## Independent Urban Design Advice

MAY 2020

1. In July 2015, I was asked by the City of Yarra to comment on the proposed rezoning and mixed use development of the site at 462-482 Swan Street Richmond and have evidence in the subsequent Panel for the proposed C185 Amendment.

77. Figure 1

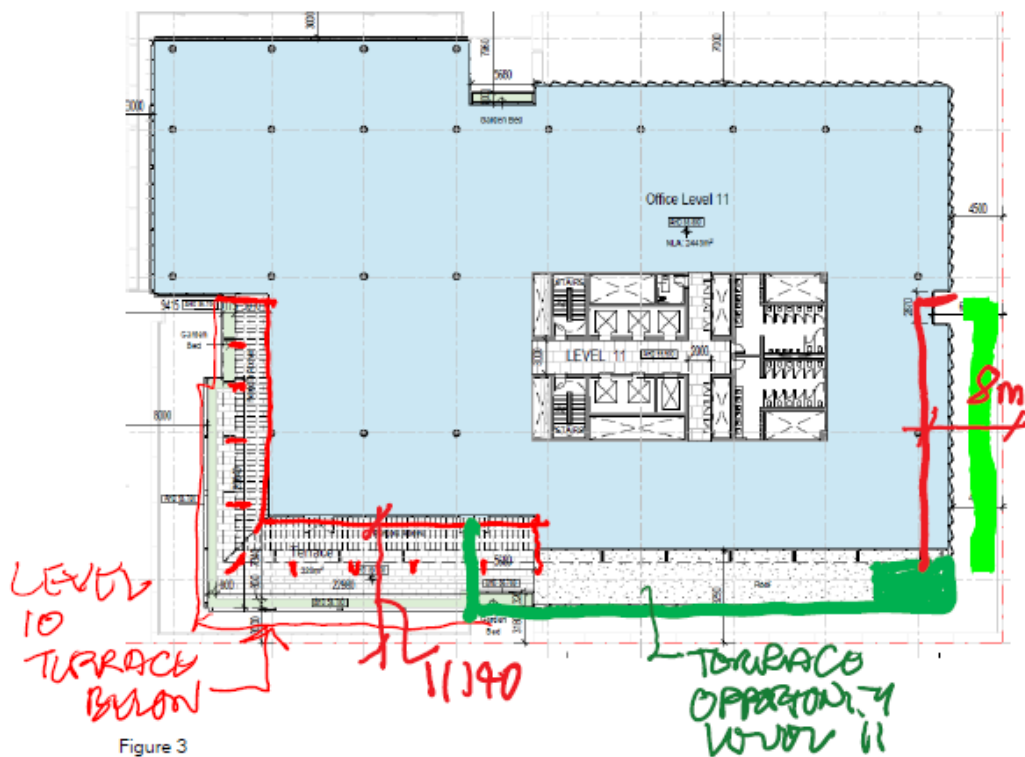
91. In my view the proposed scale of these elements is appropriate, and provide the framework for an appropriate response.
92. Of concern currently however, is the uniformity of the proposed treatment of these responses with the eastern end of the Swan Street frontage, a location in an infill setting, given the same design language and finish as the primary corner façade on Burnley Street at the principle interface of the two roads.

93. This continuity amplifies the notion of a single institution expression and conceptual solution rather than addressing the fine grain character, diversity and richness of detail and materiality characteristic of this part of Richmond.

94. The response is inconsistent with the richness of response to context sort in the Local Policy and DDO provisions in my view and as underlined in the report.

95. An opportunity for example may exist to draw on the earlier industrial history of the site as a Timber Yards and Mills in the hinterland Station interface expression noting the use in a more polished and corporate manner in the soffit treatments of the projecting canopy corner.

I would invite the applicant to review the design expression east of the primary north south entrance in Swan Street for each of the podium levels and the Burnley Street zone south of the projecting corner form to explore opportunities to invest the narrative of the site with a deeper and more diversified response to the precinct, its subdivision character and its history consistent with the Objectives and Guidelines goals outlined in CI 22.10-3.2 *Urban form and character*.

Figure 2

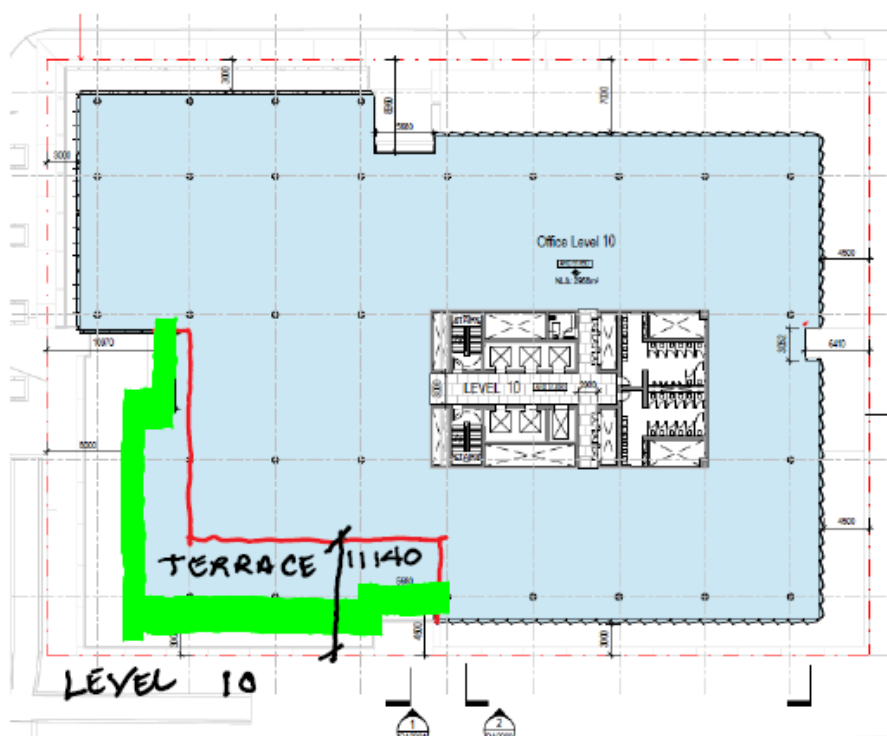
96. Similarly it is my view that the reduced setback proposed to the eastern façade combined with the absence of increased upper level setbacks have in combination failed to meet the necessary benchmarks by the provisions within local policy and the DDO without amendment for delivery of design excellence in outcome, visual break between forms and design interest and articulation in response to the site context.
97. The eastern façade is dependent on the adjoining proposed building being developed. Without this its uniform expression lets down what is otherwise generally a cleverly composed development.

98. The east elevation also needs to consider the aspect of the built form when seen from more distant locations residential neighbourhoods to the SE and the eastern Swan Street corridor.

- a. At Level 11 Setback the eastern façade 8m from the eastern boundary for the section from approximately 1m south of Gridline 3 to the to the south façade as shown in Figure 2 above.
- b. Consider revising the south roof zone as a landscaped terrace.
